BOARD ACTION REPORT – APPEALABLE ITEM

Project Name: 7-Eleven

Project Location: 16000 S. Military Trail

SITE PLAN REVIEW AND APPEARANCE BOARD STAFF REPORT

SITE PLAN

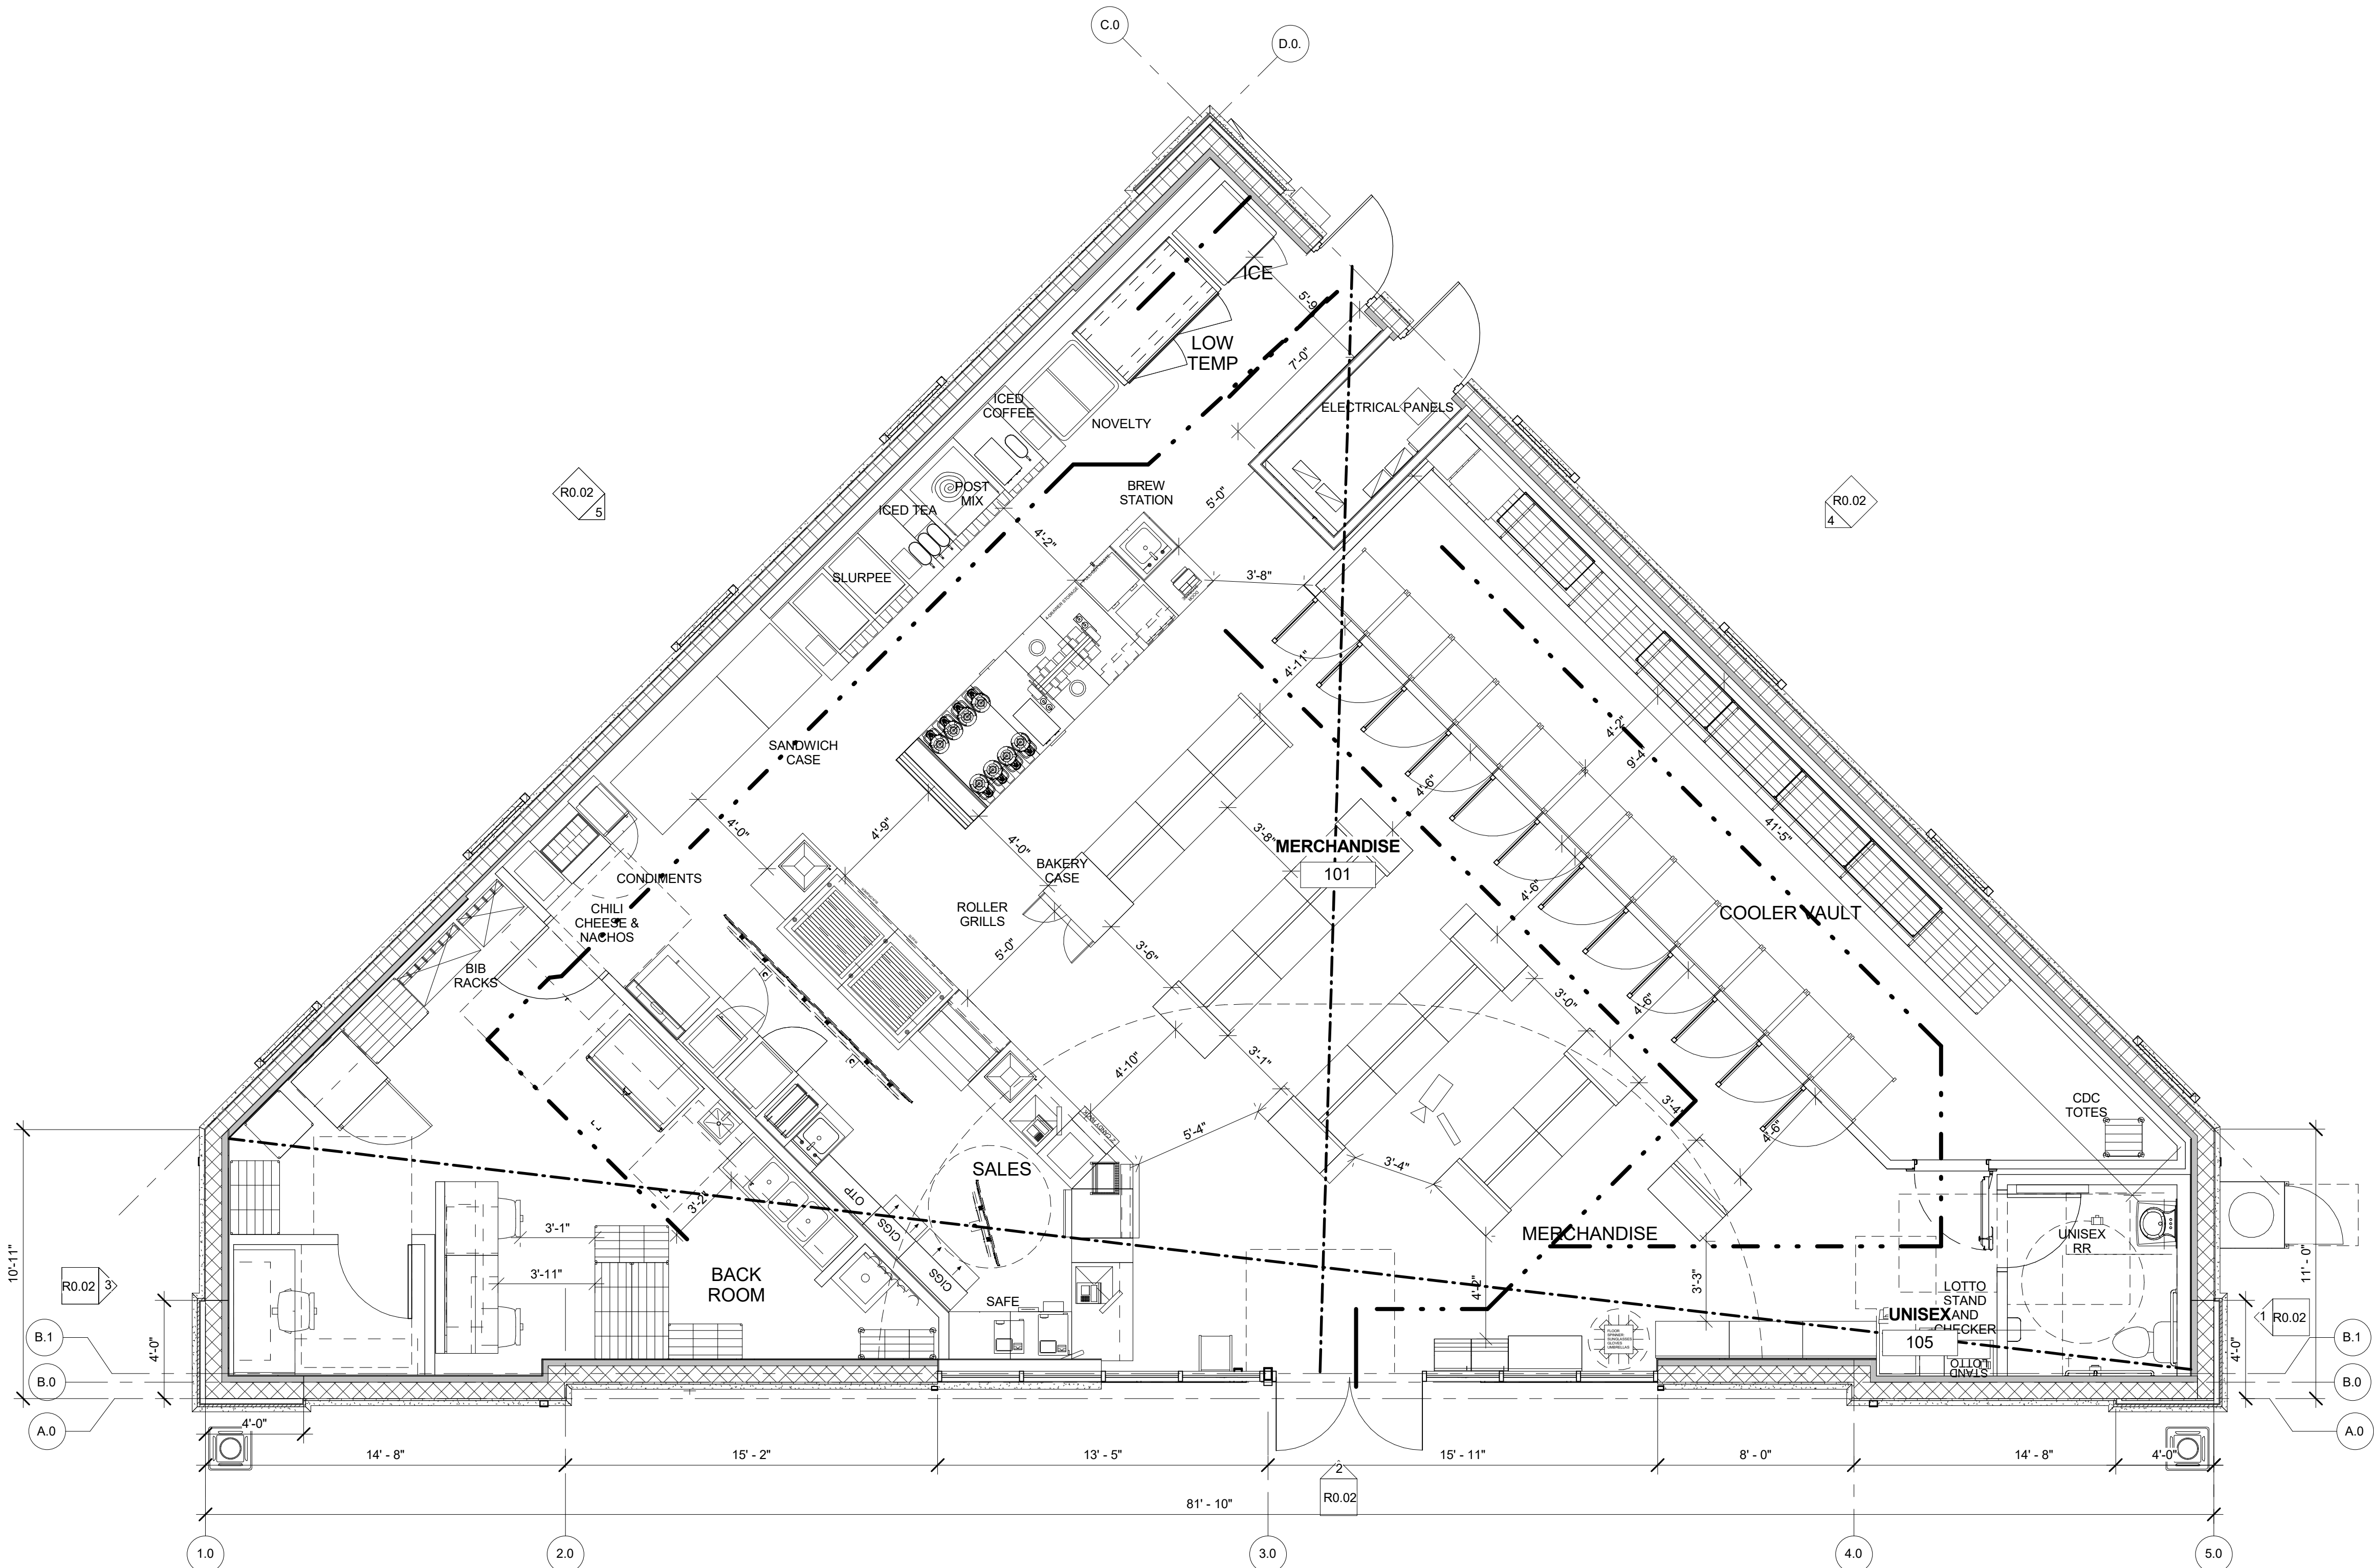
1. Prior to building permit issuance, the portion of Utility Easement PB 51, PG 118, located under the proposed building must be abandoned.

The proposed tanks, canopies and dispensers islands exceed 15 feet from the nearest property line. The tanks are approximately 20 feet from the property line and the canopy is approximately 35 feet from the property line. The subject parcel does not abut any residentially zoned property.

No vending machines or tire sales are proposed and oil sales will be conducted inside only. However, CO2 and Propane tanks stored in cages are proposed along the northeast face of the building, which faces West Linton Boulevard. Per LDR Section 4.6.6(C)(2), Outside Storage, materials and equipment stored outside must be screened from view from public rights-of-ways in a manner approved by the Site Plan Review and Appearance Board. The tanks and cages will be screened from Linton Boulevard by the provided landscaping.

Pursuant to LDR Section 4.3.3, convenience marts shall provide 4.5 parking spaces per 1,000 square feet of gross floor area. Currently, 9 parking space are located along the southern property line of the existing facility. These spaces are part of a shared parking agreement for the Linton Oaks Square shopping center. The applicant is required to provide 12 parking spaces for the proposed 2,538 sf convenience mart, but has provided 21 parking spaces, including one ADA parking space. The total spaces reflect the original approved amount of spaces for Linton Oaks Square plus the additional spaces needed for the expansion of the convenience mart. Anticipated deliveries to the convenience mart will be via box truck and gas tanker. As the structure size of the mart is less than the square footage that requires a loading area, loading will be done within one of the parking spaces. The gas tankers will unload near the tanks. Although the tanker may block one entrance to the mart, two additional entrances will be available for patrons to utilize.
